Access Compliance Report

Public Rights-of-Way

(Curb Ramps)

Intersection ID: 23730	Main Street: PROVIDENCE_RD	Cross Street: CEDAR_CROFT_DR	Location: SE
ADA ID: 32572F8A41C7	Ramp Type: Perp	Initial Pass/Fail: Fail	Overall Compliance: No
Severity Score: 21.25			
Codes/Mitigation Info/Possible Solution		Field Measurements/Component Compliance

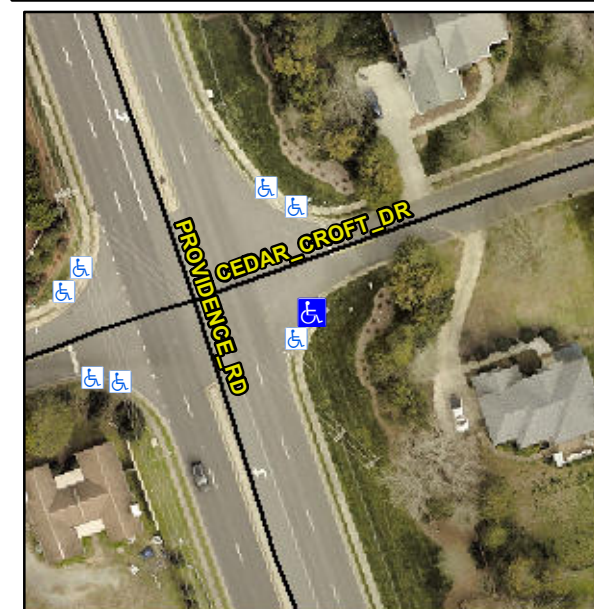
Surveyor Notes:

N/A

PROW/ADA:

R304.5.1, R304.2.2

Compliance	Description	Data	Compliance	Description	Data
N/A	Ramp Length (in)	60.0	No	Ramp Slope (%)	10.6
No	Ramp Width (in)	42.0	Yes	Ramp XSlope (%)	1.4
N/A	Flare Type LT	N/A	N/A	Flare Type RT	N/A
N/A	Flare Slope LT (%)	N/A	N/A	Flare Slope RT (%)	N/A
N/A	Flare Traversable LT?	N/A	N/A	Flare Traversable RT?	N/A
N/A	Landing Length (in)	N/A	N/A	DWS Provided?	N/A
N/A	Landing Width (in)	N/A	N/A	DWS Contrast?	N/A
N/A	Landing Slope (%)	N/A	N/A	DWS Length (in)	N/A
N/A	Landing X Slope (%)	N/A	N/A	DWS Full Width?	N/A
N/A	Landing Curb? (Y/N)	N/A	N/A	DWS Offset (in)	N/A
N/A	Shared Landing?	N/A			
N/A	Gutter Ponding?	N/A	N/A	Gutter Slope (%)	N/A
N/A	Gutter Lip Ht (in)	N/A	N/A	Gutter X Slope (%)	N/A
N/A	Painted X Walk1?	No	N/A	Painted X Walk2?	N/A
	X Walk 1 Direction	To N		X Walk 2 Direction	N/A
N/A	X Walk 1 Width (in)	N/A	N/A	X Walk 2 Width (in)	N/A
	X Walk 1 Slope (%)	5.4		X Walk 2 Slope (%)	N/A
	X Walk 1 X Slope (%)	3.5		X Walk 2 X Slope (%)	N/A

Possible Solutions:

Remove & Replace Entire Ramp.
